CUT PATTERN	
BACK FRAME NO.	
BASE FRAME NO.	
WOOD PATTERN

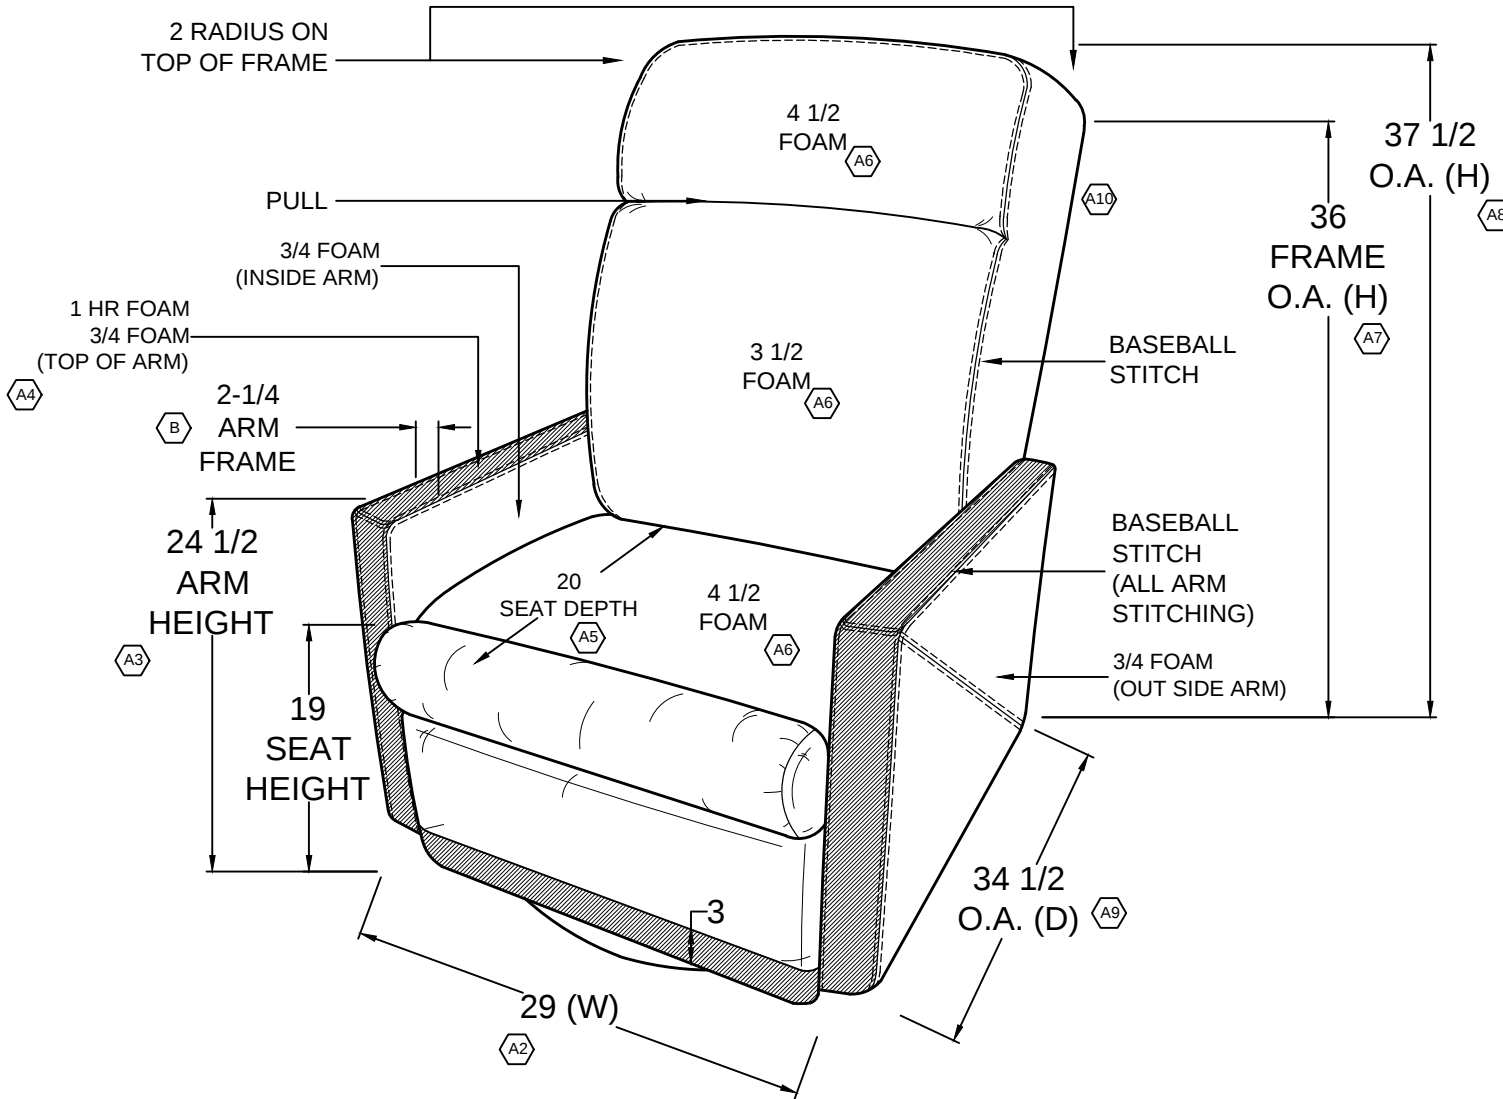
JA	B	PRODUCTION UPDATE: CHANGE ARM FRAME WIDTH TO 2-1/4"; WAS 2".	01.28.19
JA	A	PRODUCTION UPDATE: [1] ADD ARM FRAME DETAIL. [2] CHANGE WIDTH TO 29"; WAS 28-1/2". [3] CHANGE ARM HEIGHT TO 24-1/2"; WAS 27". [4] ADD FOAM DETAILS TO TOP OF ARM. [5] ADD 20" SEAT DEPTH DIM. [6] ADD BACK AND SEAT CUSHION FOAM DETAILS. [7] CHANGE FRAME HEIGHT TO 36"; WAS 38". [8] CHANGE O.A. HEIGHT TO 37-1/2"; WAS 40-1/2". [9] CHANGE DEPTH TO 34-1/2"; WAS 36-1/2". [10] ADJUSTED BACK OF PILLOW ON ISO DRAWING.	01.23.19
REVISIONS
